Subject: **Wells Dam's National NPDES Wastewater Discharge Permit No. WA0991031
Notification of Change to Outfall Locations**

**WELLS HYDROELECTRIC PROJECT NO. 2149
NPDES PERMIT NO. WA0991031**

UPDATED WATER FLOW AND DRAINAGE SYSTEM SCHEMATICS

Figure 1: Service Water System Schematic for Temperature Point Source Discharges with Discharge Changes Planned for 2024 (highlighted in yellow).

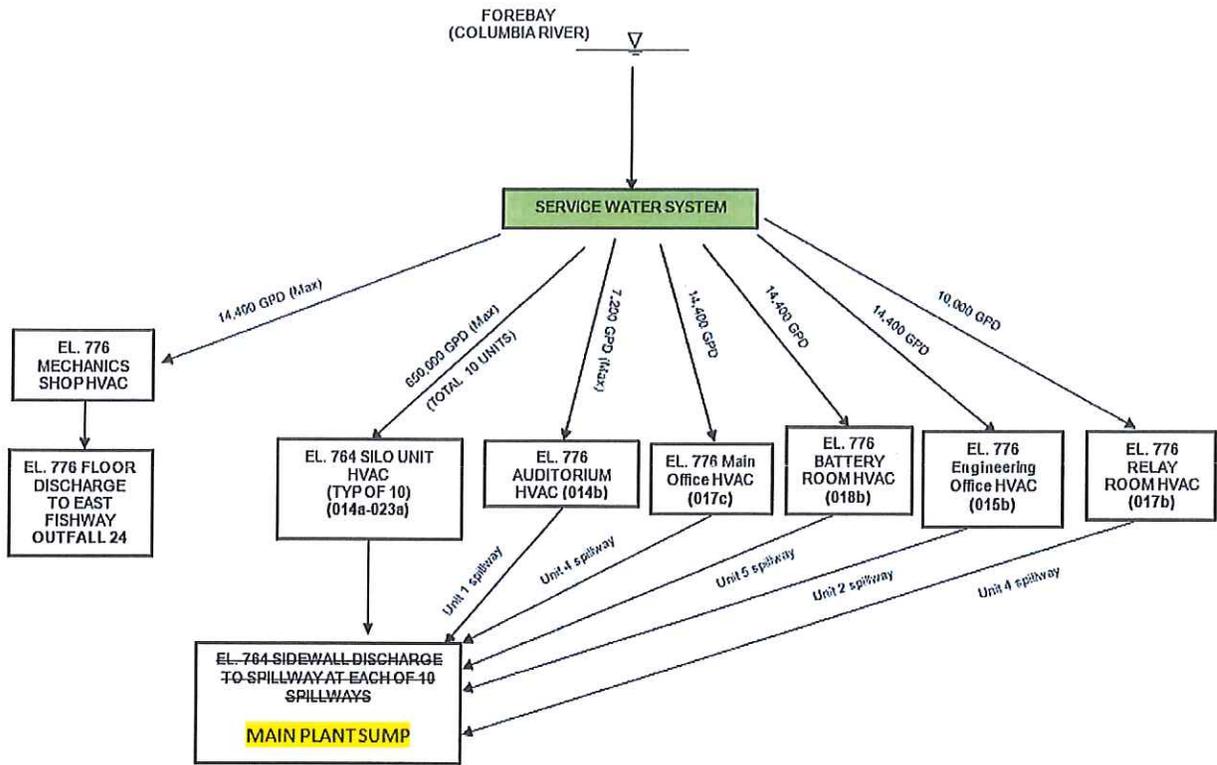
Pursuant to Section G4 and beginning 180 days after submission of this letter, Outfalls 14 – 23 will be plumbed directly into the Wells Dam drainage sump rather than directly discharging into the Columbia River. The wastewater discharge from these systems will enter the drainage sump system and be tested for Hexane Extractable Materials (HEM) and temperature as part of the routine testing for Outfall No. 1: Sump System Discharge. There will be no change to the maximum volume of wastewater discharged from the Wells Project. The proposed modification would simply change the number of outfalls tested on a regular basis since point source discharge locations would be combined as shown in Attachment A. Douglas PUD is proposing to report “no discharge” for these outfalls following replumbing and would continue as such until the permit renewal process when these point source outfall locations would be removed from the new permit application.

Combining discharge locations have a number of benefits. Outfalls 14-23 are non-contact cooling HVAC systems with limited opportunities for additive HEM products. By combining these outfalls, the number of samples taken monthly would be reduced substantially and reduce the sample burden for Douglas PUD. Additionally, any process water that travels the sump system is exposed to wastewater monitoring and process capabilities that other direct discharge does not receive. These systems include an oil alarm (detection) and oil skimmer. As such, Douglas PUD believes that the discharge location change will have either a neutral or improved environmental outcome for state surface waters.

An update process flow line diagram is attached to this letter and should replace the process water flow and drainage system schematics issued in the Permit (Attachment A).
